Device **TC29x**
Marking/Step **ES-BB, BB**
Package **see Data Sheet**

No. 029/19

This Errata Sheet describes the deviations from the current user documentation.

Figure 1 Example for Non-Power of Two PMEM

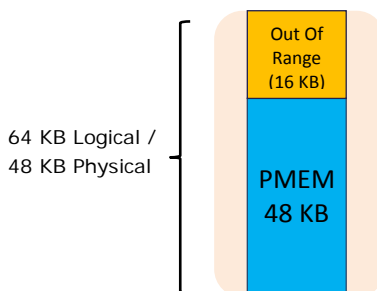
In TC29x, the following CPUs and memories are affected:

- PMEM side issue: CPU0 PMEM
- DMEM side issue: CPU1 and CPU2 DMEM.

Note: The issue only affects non-power of two PMEM and DMEM memories of a TC1.6P CPU as described above. Other CPU cores and memory configurations are not affected.

Figure 2 Message buffer transfer from Message RAM to OBF

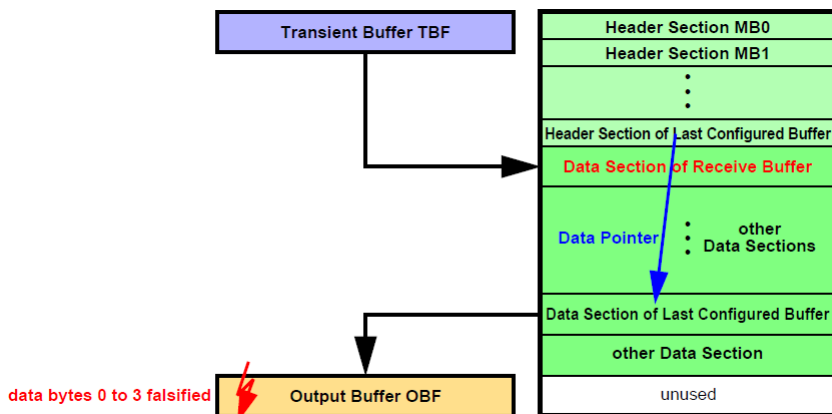
When the message buffer has its payload configured to maximum length (**PLC = 127**), the OBF word on address 00h (payload data bytes 0 to 3) is overwritten with unexpected data at the end of the transfer.

a) When a message is transferred from the Last Configured Buffer in the Message RAM to the OBF and **PLC** = 127 it may happen, that at the end of the transfer the OBF word on address 00h (payload data bytes 0 to 3) is overwritten with unexpected data (see [Figure 2](#)).

Figure 3 Message buffer transfer from IBF to Message RAM

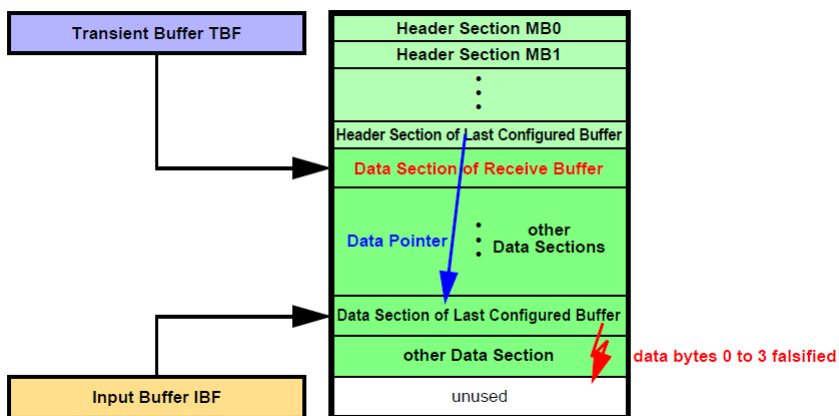
After the Data Section of the selected message buffer in the Message RAM has been written, one additional write access overwrites the following word in the Message RAM which might be the first word of the next Data Section.

b) When a message is transferred from IBF to the Last Configured Buffer in the Message RAM, it may happen, that at the end of the transfer of the Data Section one additional write access overwrites the following word, which may be the first word of another message's Data Section in the Message RAM (see [Figure 3](#)).

Figure 4 Message RAM Configurations

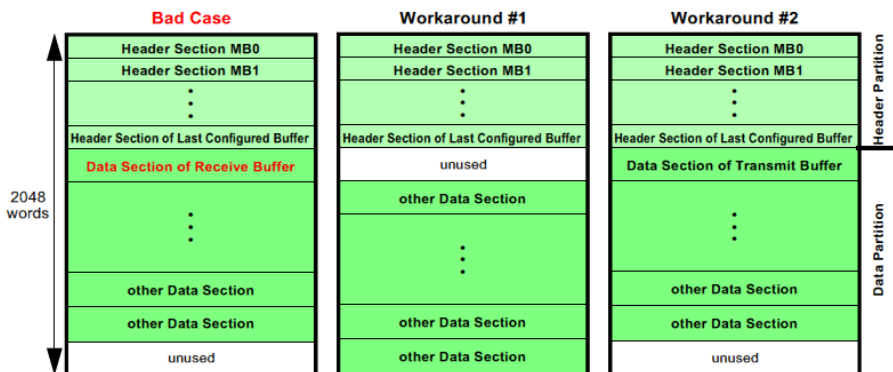
The erratum is limited to the case when (see [Figure 4](#) “Bad Case”):

2) Ensure that the Data Section directly following the Header Partition is assigned to a transmit buffer.

Figure 5 Theoretical Example for MSC Spike Scenario

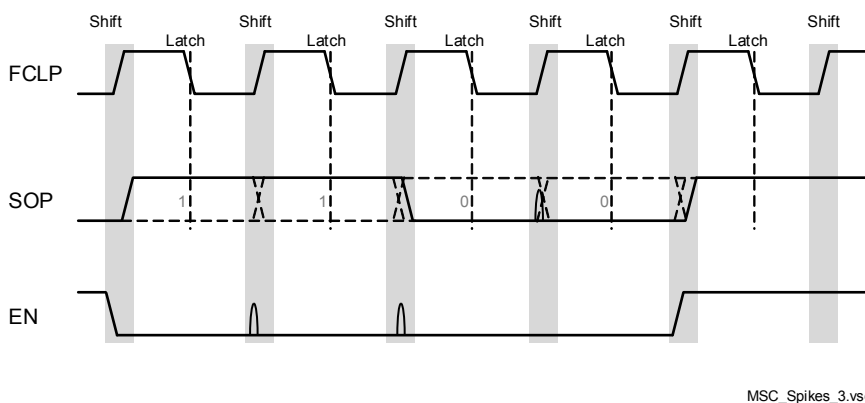
The ABRA block of the MSC generates spikes in the serial output data (SO) and enable (EN0 to EN3) signals, that under some worst case conditions might become visible at the output of the corresponding pins.

The spikes would appear as shown in **Figure 5**, within the normal signal transition timing intervals, as defined with the data sheet timings t44 (SOPx output delay) and t45 (ENx output delay). The spikes would not cause violation of the timings.

Figure 8 Phase Noise Density on SysClk Output Pin

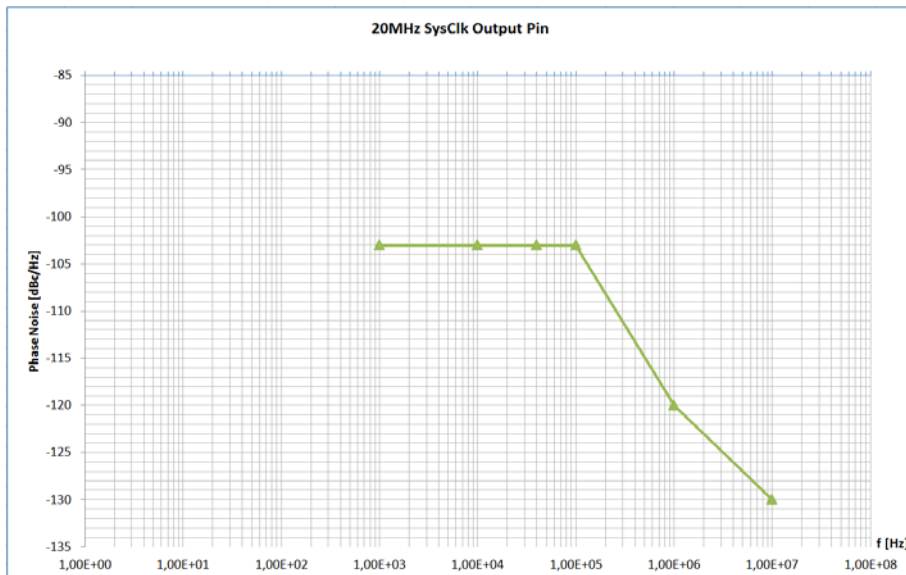
The diagram below shows the phase noise density on the SysClk pin when no application pattern but only the HSSL/HSCT subsystem is running:

Figure 10 Alert Interrupt Behavior in case of Bus-Off

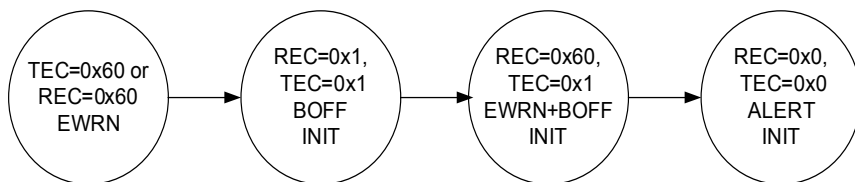
When the threshold for error warning (EWRN) is reached (default value of Error Warning Level EWRN = 0x60), then the EWRN interrupt is issued. The bus-off (BOFF) status is reached if TEC > 255 according to CAN specification, changing the MultiCAN module with REC and TEC to the same value 0x1, setting the INIT bit to 1_B, and issuing the BOFF interrupt. The bus-off recovery phase starts automatically. Every time an idle time is seen, REC is incremented. If REC = 0x60, a combined status EWRN+BOFF is reached. The corresponding interrupt can also be seen as a pre-warning interrupt, that the bus-off recovery phase will be finished soon. When the bus-off recovery phase has finished (128 times idle time have been seen on the bus), EWRN and BOFF are cleared, the ALERT interrupt bit is set and the INIT bit is still set.

Figure 12 Ripple Voltage vs. Frequency Characteristic

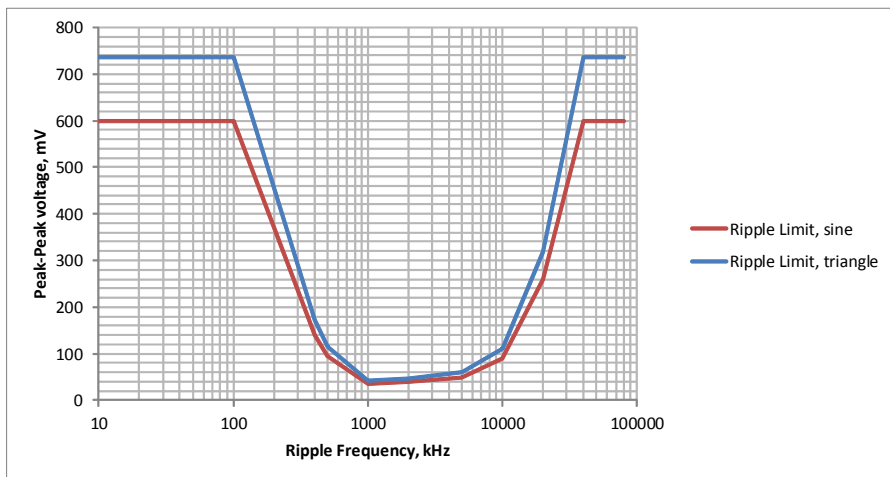
The internal back-up clock is sensitive to specific power supply voltage disturbance/ripple caused by a voltage ripple intrinsic to DC-DC converters. Specific conditions such as insufficient filtering of the ripple may lead to improper behavior of the start-up scheme of the back-up clock, and thus stuck-at state during the start-up of the microcontroller until this condition is removed.

The diagram reflects acceptable ripple level during the cold start of the microcontroller at the VDDP3 supply of the PMS subsystem. For devices in QFP-144, QFP-100 and QFP-80 packages the ripple is reflected for pin 69, pin 47, and pin 37, respectively.

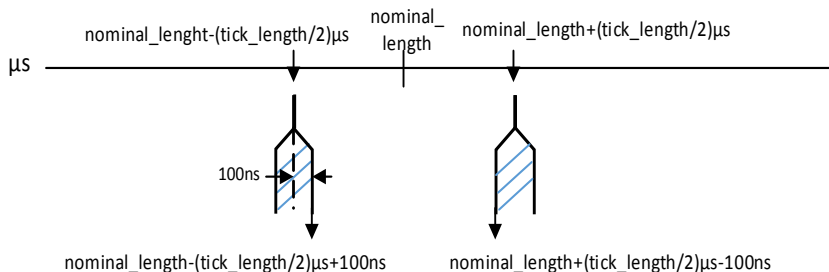
The reset value of bit field SCU_IOCR.PC1 is influenced by pin HWCFG6 and bit PMSWCR0.TRISTREQ:

- When a cold reset is activated and HWCFG6=1 then PC1 is reset to 2_H and pin $\overline{\text{ESR1}}$ will have input pull-up mode.
- If HWCFG6=0 then PC1 is reset to 0_H and $\overline{\text{ESR1}}$ will have tri-state mode.

PC1 and the $\overline{\text{ESR1}}$ reset state can also be configured by software with the PMSWCR0.TRISTREQ bit. PMSWCR0.TRISTREQ is not affected by warm reset or wake-up from standby so the IOCR.PC1 reset value is configured as per the state of the TRISTREQ bit prior to the warm reset.

Figure 15 Short Serial Message, Serial Data Encoding over 16 messages

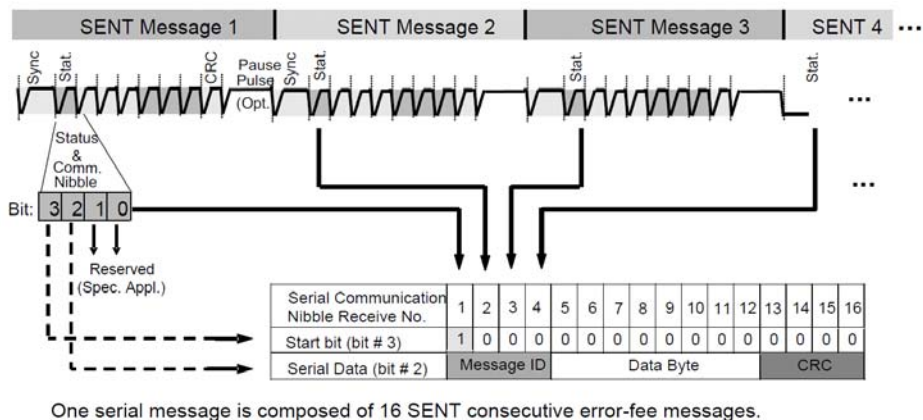
Figure 15 shows a corrected version of this figure.
